召回一批双缸点火系统

Recall a batch twin ignition system

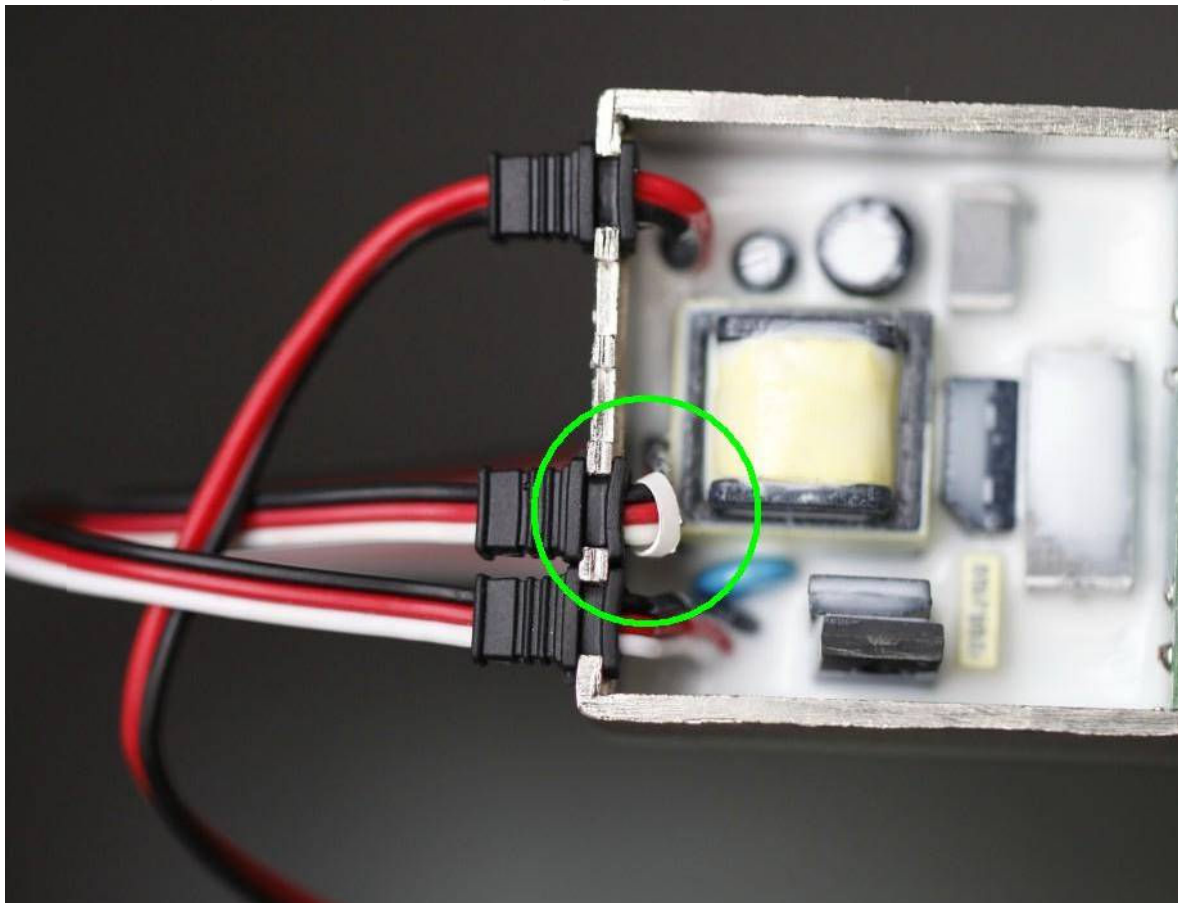
数量约 1000 只,发货时间范围,2010 年 9 月~2011 年 4 月
因该批点火系统程序错误,会引起手启动困难,必须用力拨,
但如果使用启动器没有问题,,或移动霍尔传感器到 34 度提前角也可以使用.
如手启动有困难的双缸点火器,请检查是否有如下特征.
该批号特征如下,揭开外壳底部商标,打开底壳,转速信号线套有白色套管的标记,就有可能在此批次.详细见图.,其他批次没有任何问题.

Quantity to about 1000 pcs , shipping time about , September 2010 ~ April 2011
Because program errors the ignition system of the batch Hand-start the engine will cause difficulties, They cant be hand started by flipping the prop as usual.Each one, if there is no problem using the starter or setting the timing at 34 degrees BTDC and they started perfectly.
If the hand is difficult to start the engine, please check to see if there are features
The batch features are as follows
Opened the ignition box bottom of the label, Open the bottom shell, speed RPM signal lines marked with white casing, It is possible in this batch
Details see Fig., The other batch without any problems
